# Assawogga Heights II

Killingly, Connecticut

Environmental Review Team  
Report  
on

March 1979

Parcel Location

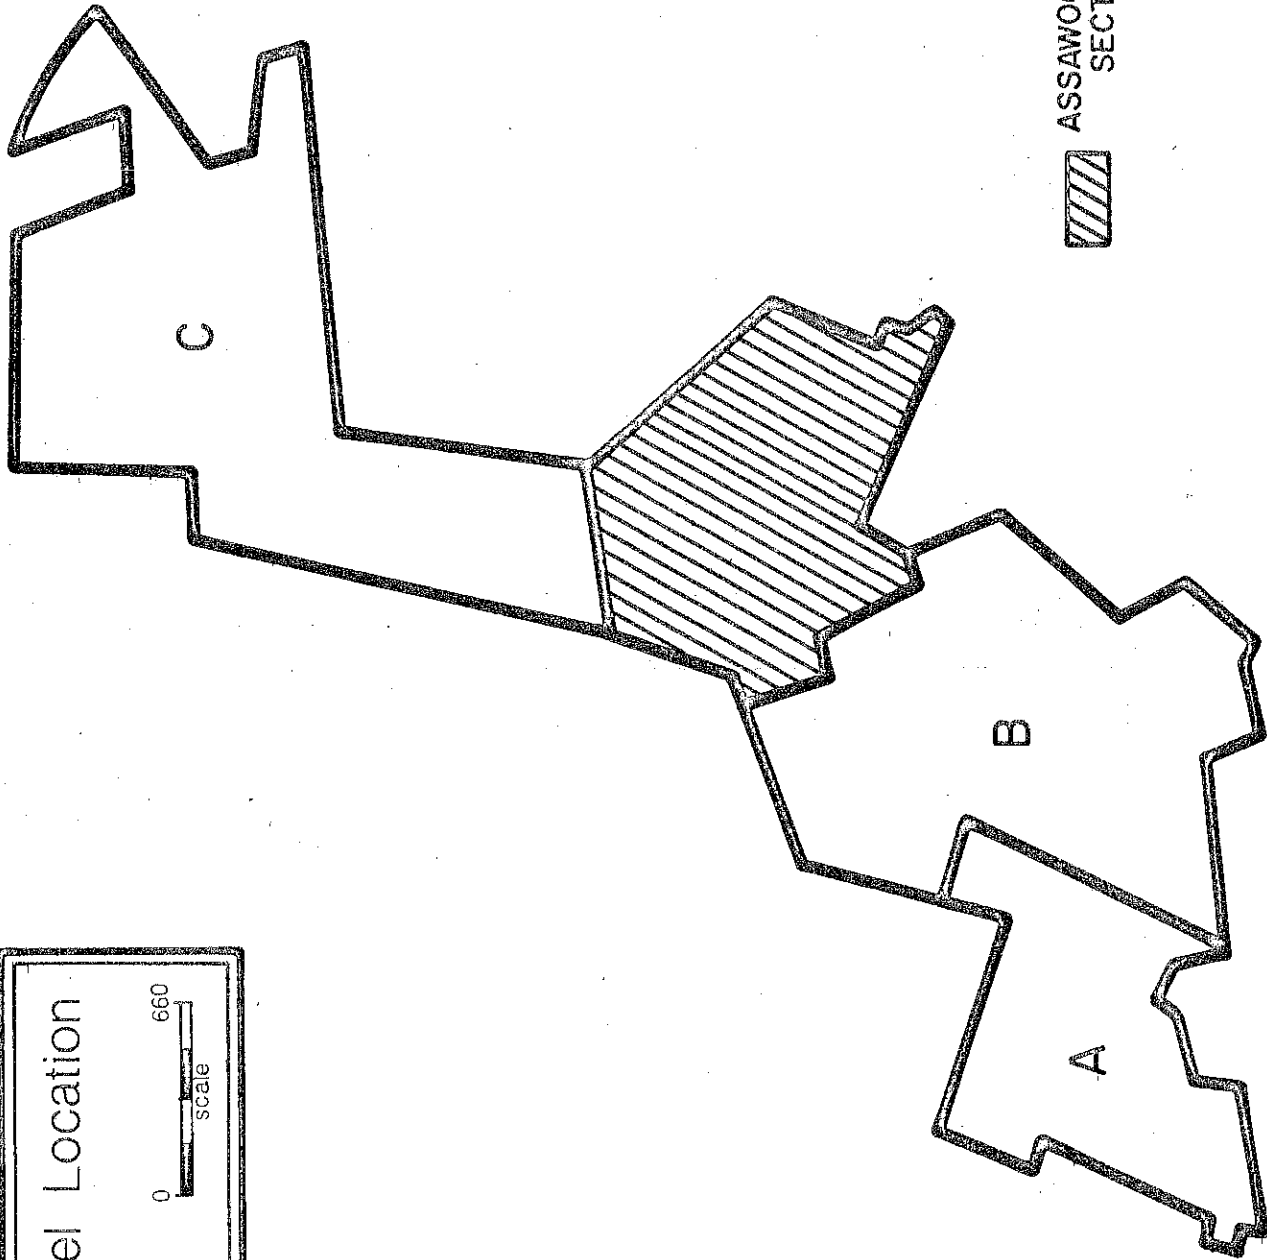
Parcel A: A low drainageway or band of wetland soils (43M) forms a semi-circle on the eastern portion of parcel A. Runoff is conveyed to an excavated pond on the property, and then eventually to a culvert beneath Rte. 12. The small excavated pond presently acts as a crude storm water retention basin. Between the pond and Rte. 12 is a roughly shaped outlet channel, much of its is obstructed with boulders. It appears this outlet channel is not within the property of Clover Development. Any increase in flow caused because of additional developmental runoff should be adequately accommodated by properly constructing the channel. It is likely that a heavy flow presently spreads out onto an adjacent pasture south of this area. The existing pond could very easily be modified to act as a combination sediment and runoff retention pond.

It would be best to stay back from the edge of the semi-circular wetland when developing this parcel. Construction limits could be appropriately set, with a row of hay bales staked in place where land grading approached the swamp. The natural filter of existing grassed ground above the swamp should be retained.

With the installation of an access drive between parcel A and B, harmful effects to the wetland can be minimized. It appears that the open swampy area immediately north of the planned road could be left undisturbed. This area coupled with its woodland edge provides good wildlife habitat for songbirds, possibly ducks and other smaller terrestrial wildlife. A culvert placed beneath this road must be sized properly and placed on firm base. Its invert elevation should be about level with or slightly below the water surface in the small open area. Stabilization of the slopes as soon as possible after final grading will be important. Hay bales should be staked at the toe of the filled slopes through the wetland if a seasonal delay in vegetating or mulching the slopes is expected. If a considerable volume of water, possibly increased by street storm drainage, is expected to flow through the culvert, placing some rip rap at the outlet would be appropriate. A minimum height of road fill will lessen the base width of the road through the swamp.

Parcel B: Plans show the approximate location of the proposed development road. Where the road curves above the wetland area a few hundred feet before it joins Ballouville Road it could be moved westward, farther away from the steep slope into the wetland. This particular wetland is several acres large with a stream flowing through it. It serves, as did the semi-circular wetland in parcel A, to filter watershed runoff to it and release it slowly to downstream watercourses. This function aids in preventing floods. Any street storm drainage outletting into this area should be noted. Rip rap outlet sections may be in order to avoid erosion and sedimentation at the edges of the wetland.

Parcel C: Plans show consideration for the wetlands on the east and west side of the proposal. Disrupting as small portions of the field as is practical for individual unit construction would be best. Leaving filter strips of existing vegetation will alleviate a potential erosion problem. The topsoil now present will be an asset in landscaping the project. The planned pond may need some protection
